Town of Brookline
Massachusetts

To: Brookline Board of Appeals

Date: September 8, 2016

Subject: Create a common driveway, construct garage and provide all parking for 29-31 Winthrop Road and 33 Winthrop Road on front lot

Appendix A: Permitted Layout

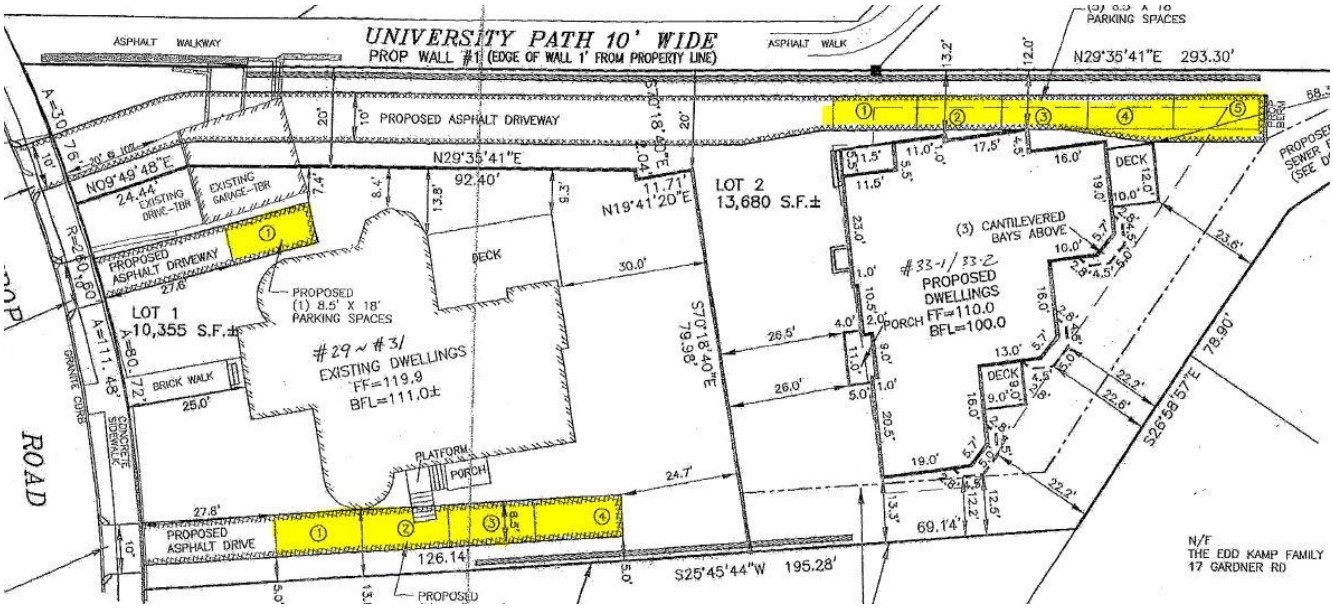
The applicant has an as-of-right proposed permitted layout which includes all the required parking. The existing garage at 29-31 Winthrop Road has been removed to allow for the construction of an asphalt driveway to accommodate for the parking for the new dwelling at 33 Winthrop Road, as well as the parking at 29-31 Winthrop Road (See Appendix A).

The as-of-right parking plan for the existing home at 29-31 Winthrop Road consists of 4 tandem spaces along the east side of the building and one space at the south side of the lot.
The as-of-right parking plan for the new two-family home at 33 Winthrop Road consists of five

Appendix B: Proposed Parking Layout

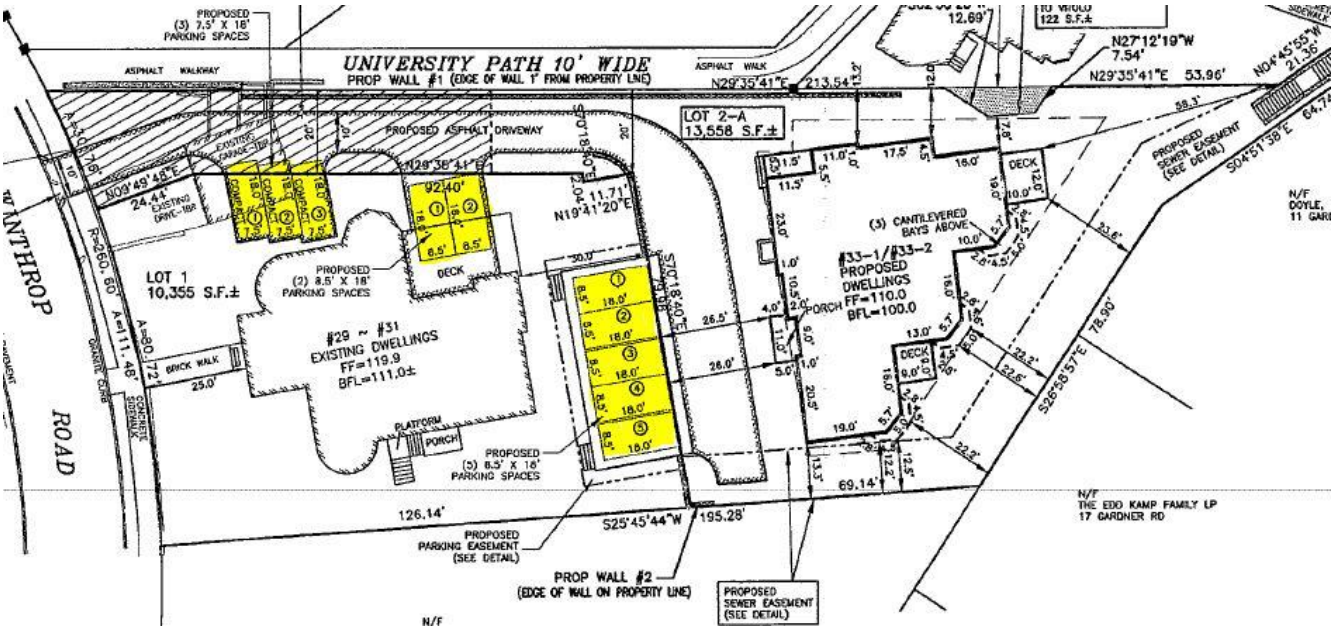
The new parking proposal places all the required parking for both 29-31 Winthrop Road and 33 Winthrop Road on the front lot. By proposing to place all of the parking (10 spaces) onto one lot, the number of spaces is greater than six, and therefore not exempt from **Section 6.03**. A special permit would be required to waive the dimensional relief for the parking.

The Applicant is proposing to create a common driveway that runs northwesterly along the lot line for 29-31 Winthrop Road. Along the common drive are five parking spaces (3 compact and 2 regular) for 29-31 Winthrop Road. As the proposed common drive wraps around the property line, it allows access to an underground parking structure at the rear of 29-31 Winthrop Road with 5 parking spaces to serve 33 Winthrop Road (See Appendix B)

Appendix C: Underground Parking Structure

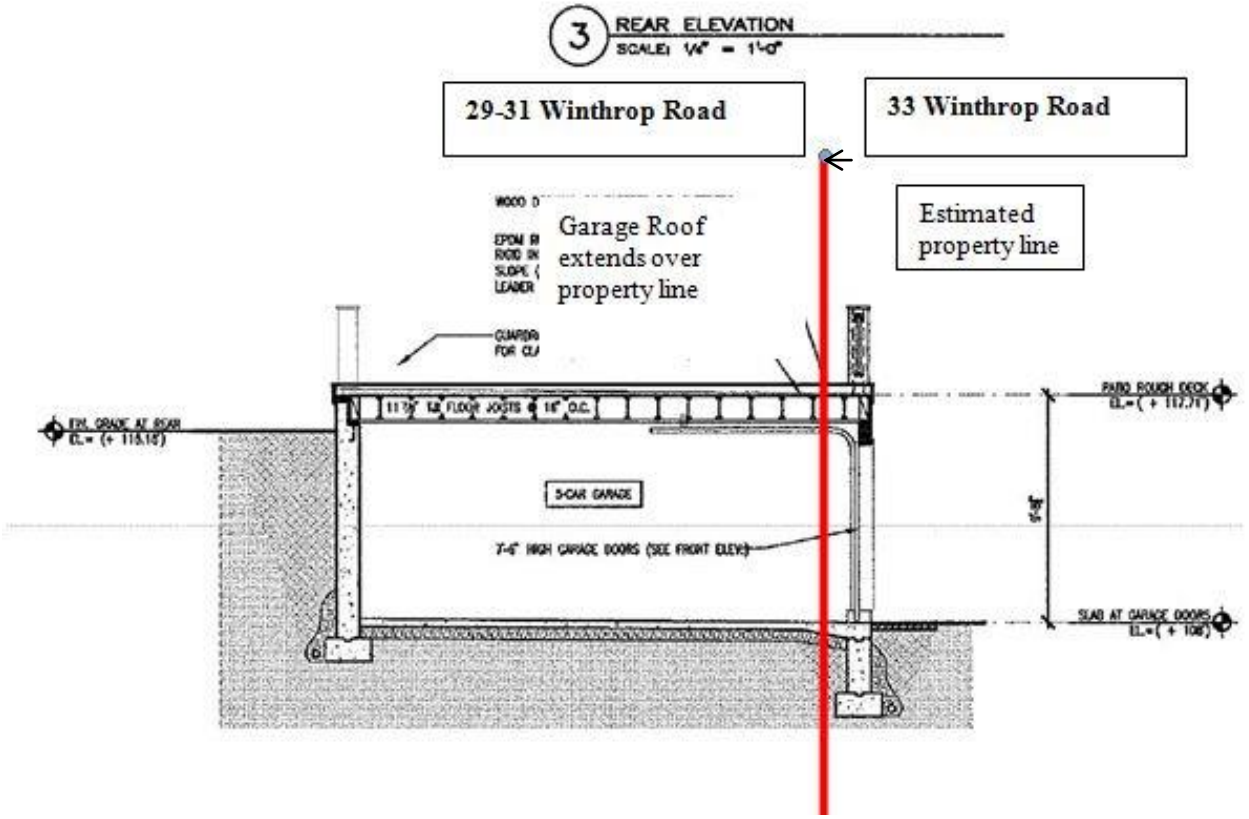
Section 5.44.3, 4: Accessory Underground Structures: The Board of Appeals may by special permit authorize such an accessory underground garage structure or part of a main building which is not located entirely beneath the surface of the ground at the natural grade level within a required front yard provided: a) The structure shall meet all the conditions of paragraph 2, no parking on the roof of such structure, no parked vehicles shall be seen from the street (See Appendix C).

Relief Required: The Board of Appeals may by special permit modify the setback requirements as long as counterbalancing amenities are provided as well as appropriate landscaping and screening.

Appendix D: Driveway Dimensions

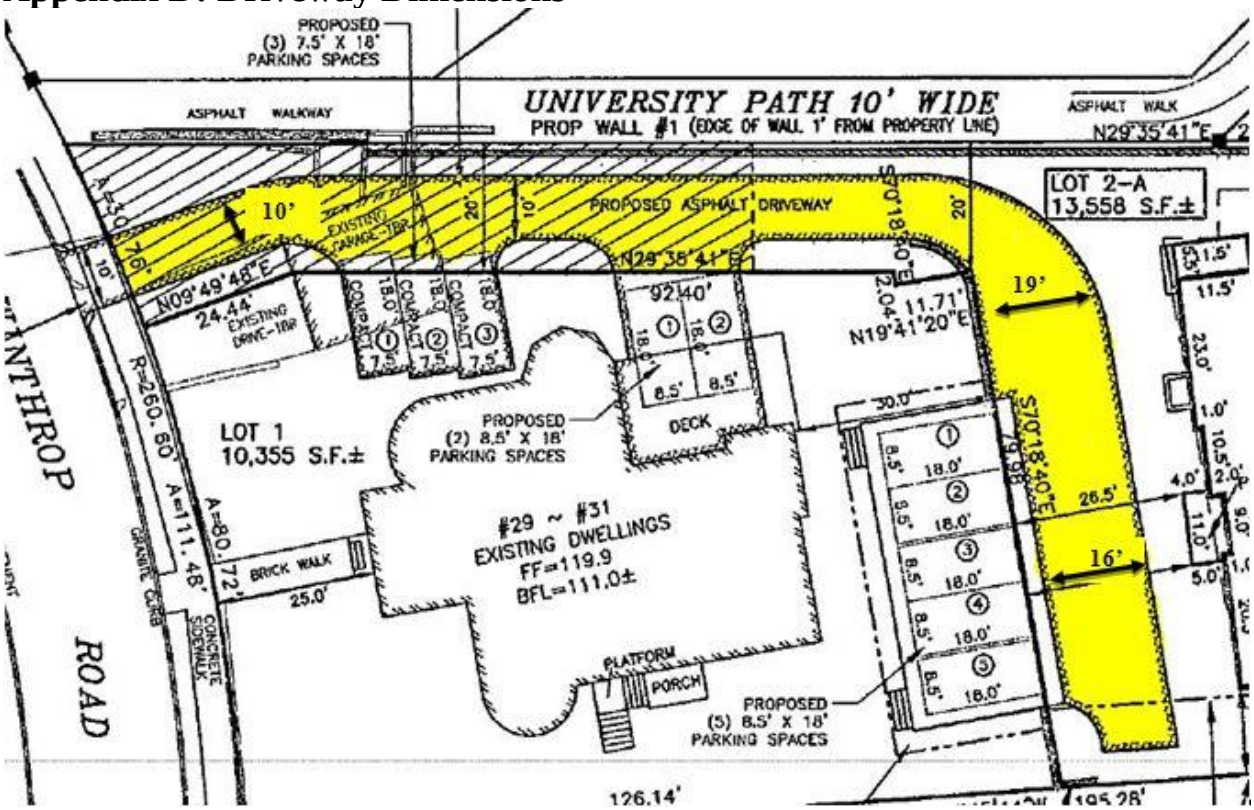
Section 6.04.4.b: Design of All Off-Street Parking Facilities: Entrance and exit drives shall be a minimum of 20 feet wide for two-way use. The majority of the proposed driveway is 10 feet wide, with the exception of the portion of the driveway behind the entrance to the parking structure at the rear at 19' and 16' (See Appendix D).

Relief Required: Variance

Appendix E: Parking Space Location in Relation to Building Footprint

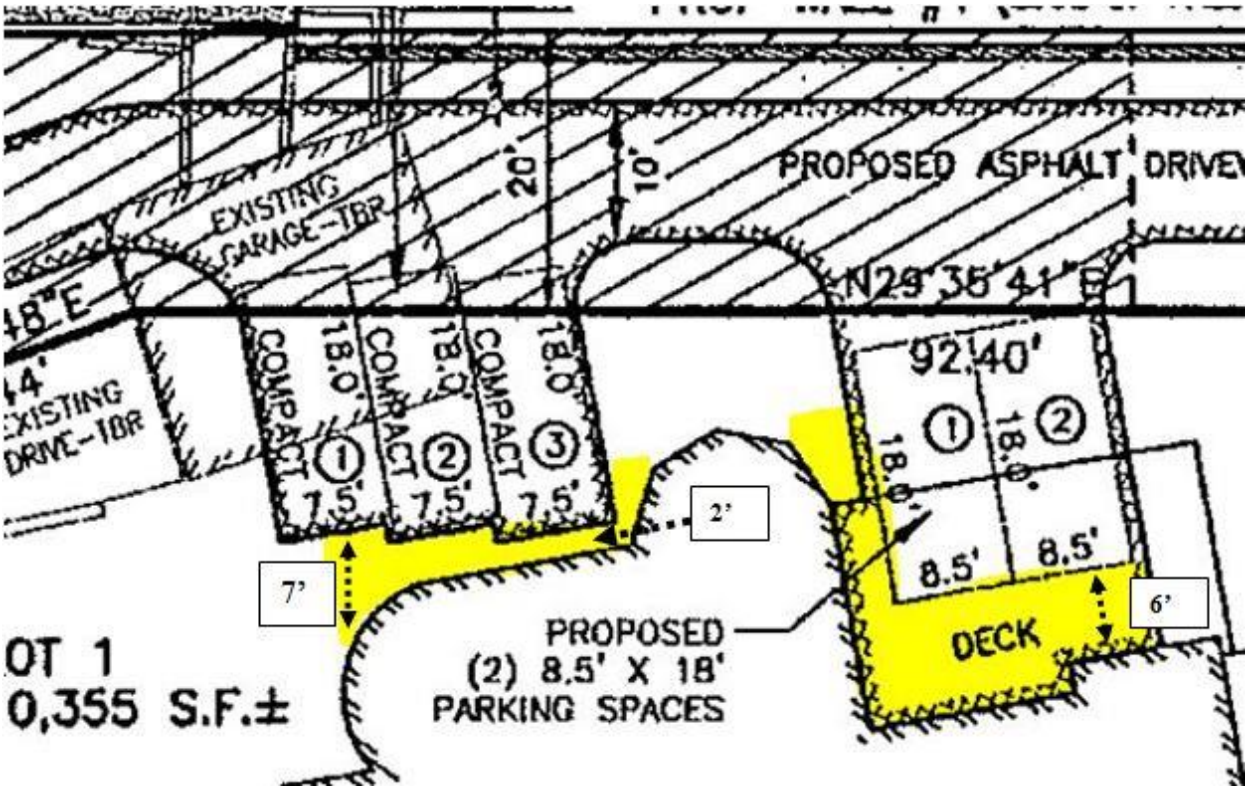
Section 6.04.7: Design of All Off-Street Parking Facilities: No stall shall be located within 10 feet of a building having windows of habitable rooms at the basement or first-story level.

Relief Required: The applicant has not provided enough information regarding where existing windows are in relation to the proposed parking. The building footprint does come within 10' of the proposed parking (See Appendix E).
